# Conceptual Review Agenda

Schedule for 03/14/16 to 03/14/16

# 3036 Environmental Dr Solar Array

Figure 1: Candidate array location

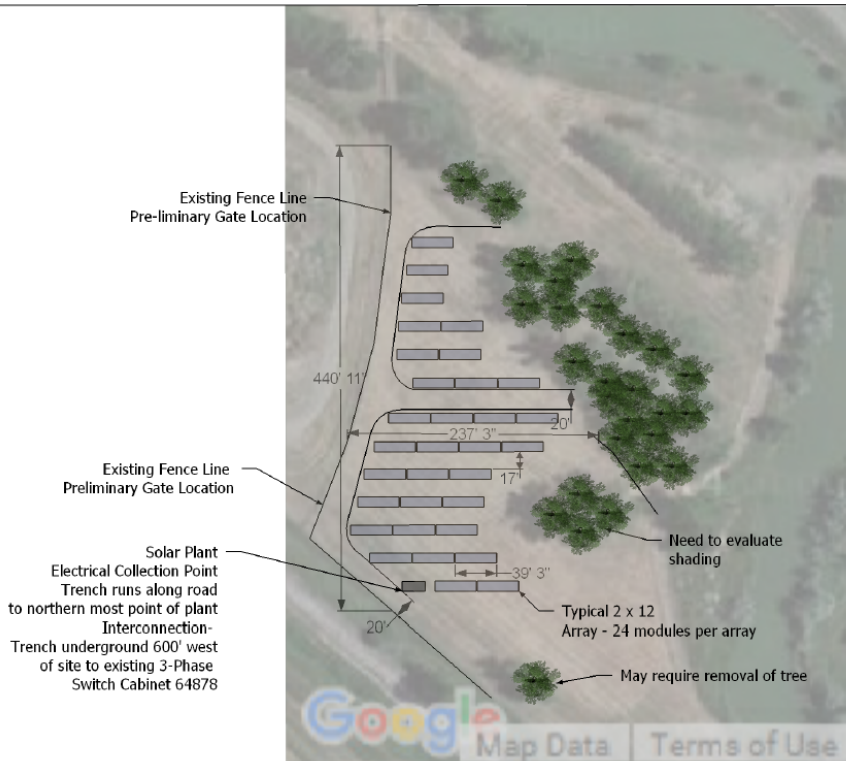
1. The site disturbs more than 10,000 sq. ft., therefore Erosion and Sediment Control Materials need to be submitted. The erosion control requirements are in the Stormwater Design Criteria under the Amendments of Volume 3 Chapter 7 Section 1.3.3. Current Erosion Control Materials Submitted do not meet requirements. Please submit; Erosion Control Plan, Erosion Control Report, and an Escrow / Security Calculation. Also, based upon the area of disturbance State permits for stormwater will be required since the site is over an acre. If you need clarification concerning the erosion control section, or if there are any questions please contact Jesse Schlam 970-218-2932 or email [@ jschlam@fcgov.com](mailto:jschlam@fcgov.com)

2. Any stormwater design done of this site must conform to the drainage basin design of the Cache La Poudre Master Drainage Plan.
3. If there is an increase in imperviousness greater than 1000 square feet a drainage report and construction plans are required and they must be prepared by a Professional Engineer registered in the State of Colorado. If there is less than 1,000 square feet of new impervious area on an existing development, a drainage letter along with a grading plan should be sufficient to document the existing and proposed drainage patterns.

6. There are no detention, water quality or LID requirements for the solar farm itself. However, any new access roads would require mitigation. See comment below.

ELEVATED DECK LEVEL

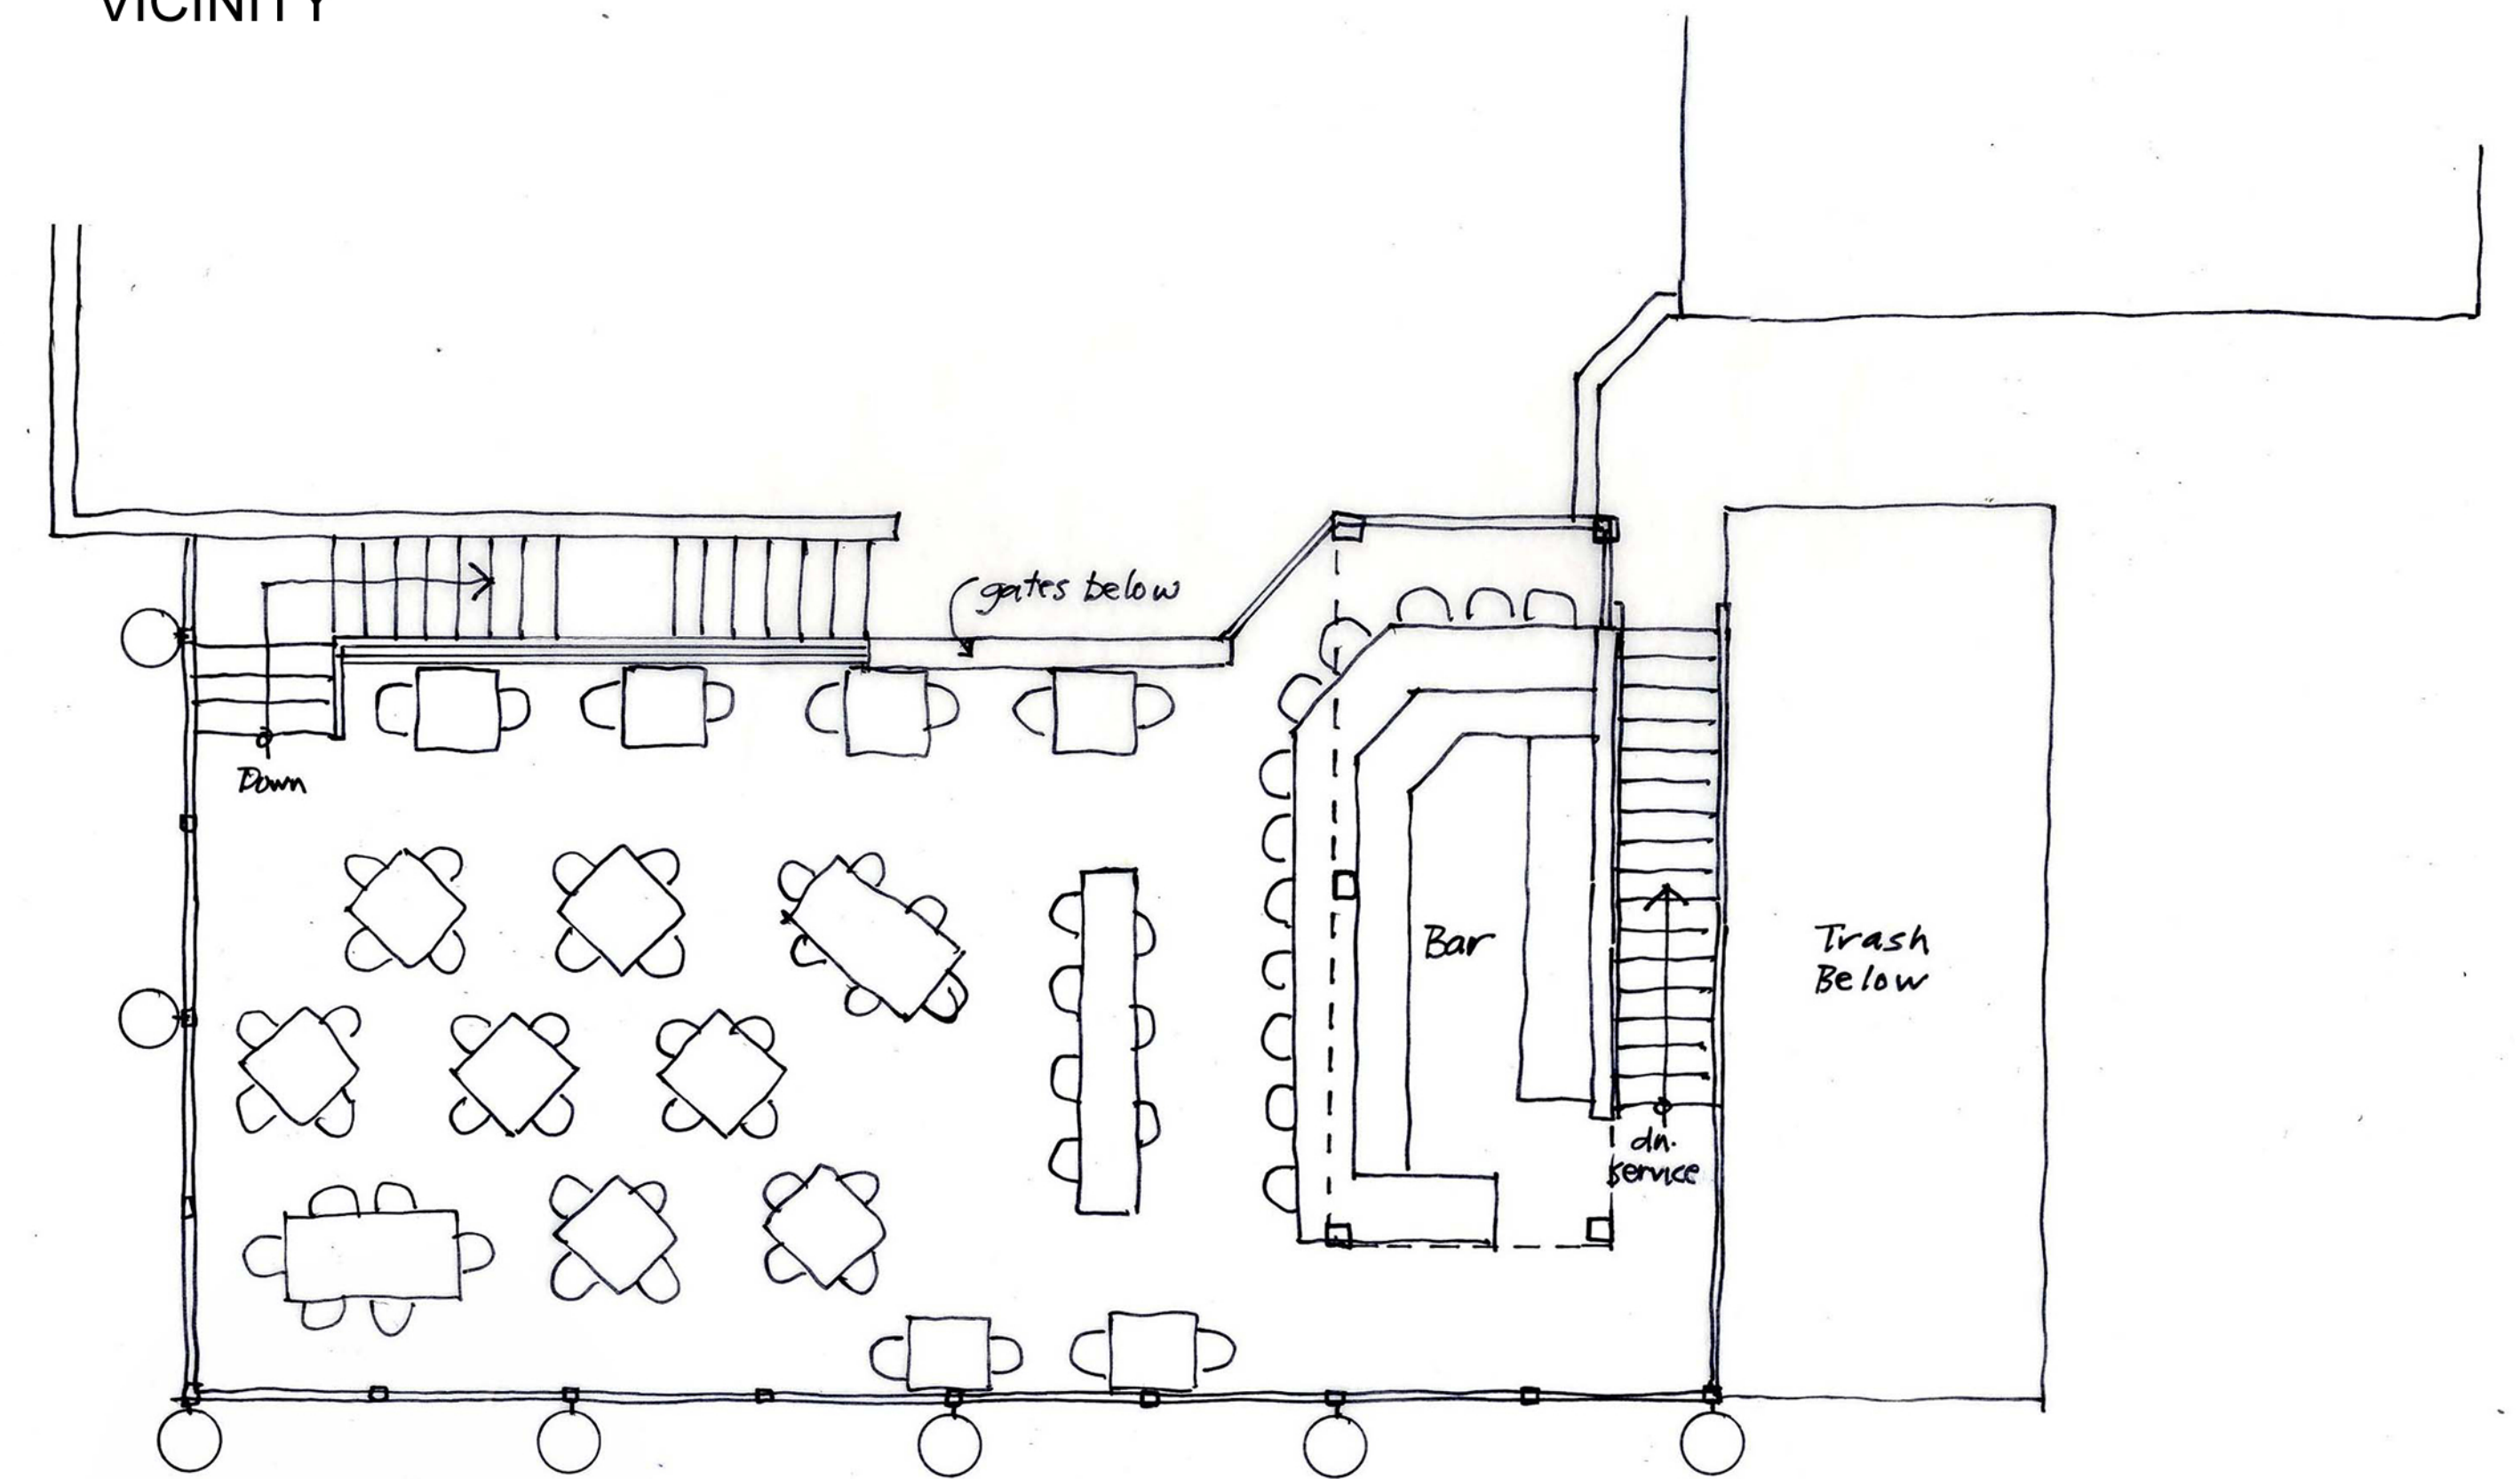
1. EXITING  
Further study of the exiting plan will be needed. The Occupant Load (OL) of the elevated deck exceeds 49 persons and as two means of egress are required, under the current plan, 1/2 of the OL will empty directly into the existing courtyard which will impact the OL of that space. Two exits from the courtyard are required if that OL exceeds 49 and that has potential to influence the OL of the main restaurant if the courtyard cannot provide for it's own egress requirements without the occupants needing to enter the restaurant in order to exit the area. Further information will be needed at time of tenant finish to ensure adequate exiting has been achieved for all areas, existing and proposed. Code language provided below.

Reconfigured  
Shenandoah parcel

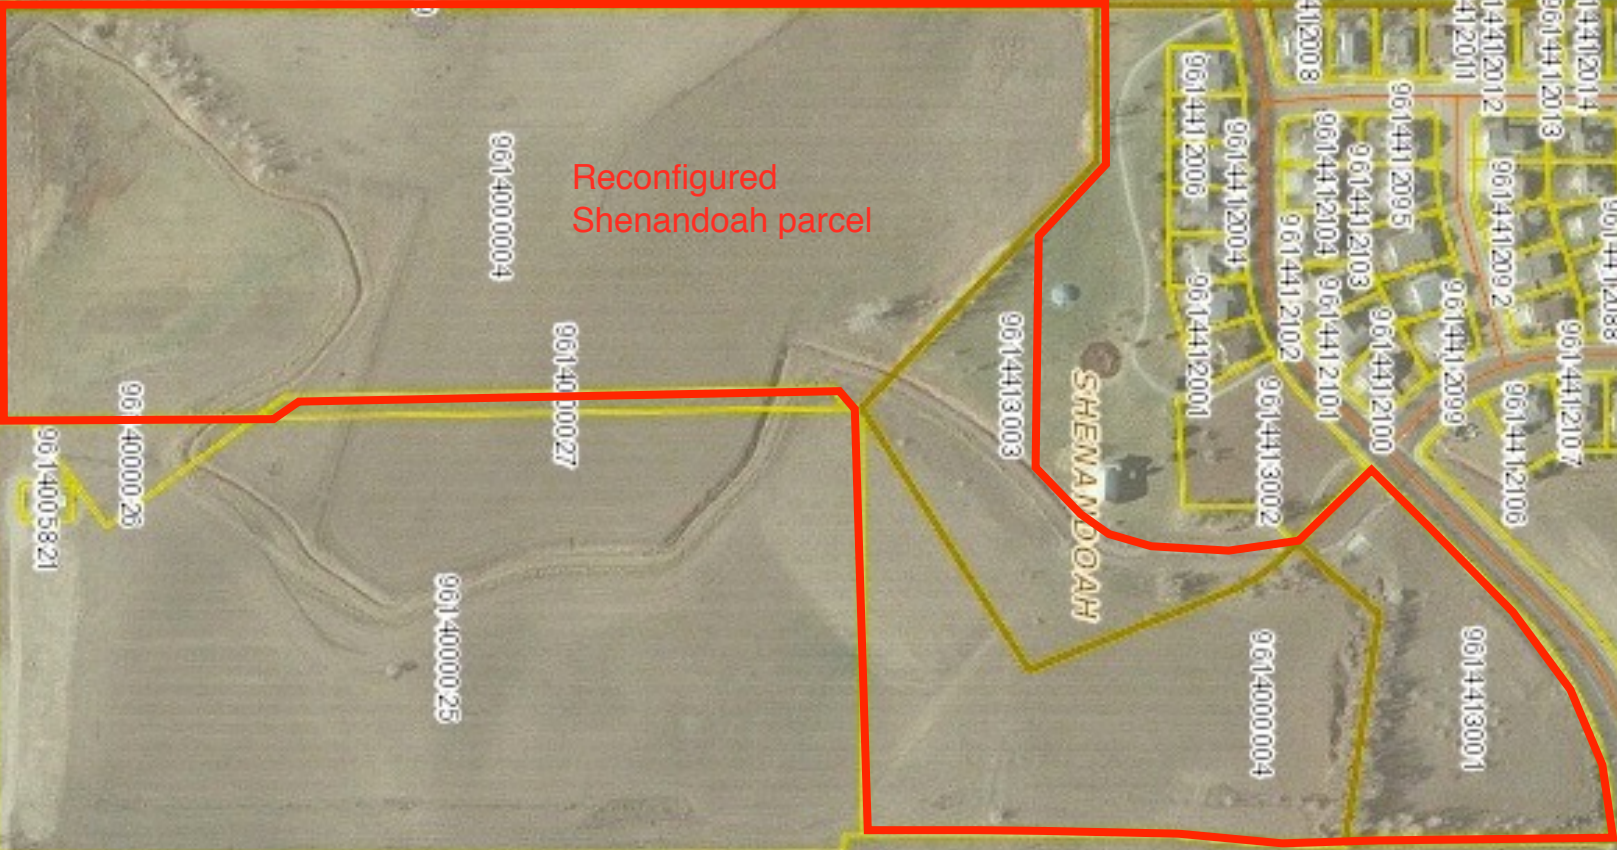
9. Only full roads (curb to curb) can be built. As shown on the submitted drawing right-of-way from the adjacent properties will need to be dedicated to complete the infrastructure as shown.
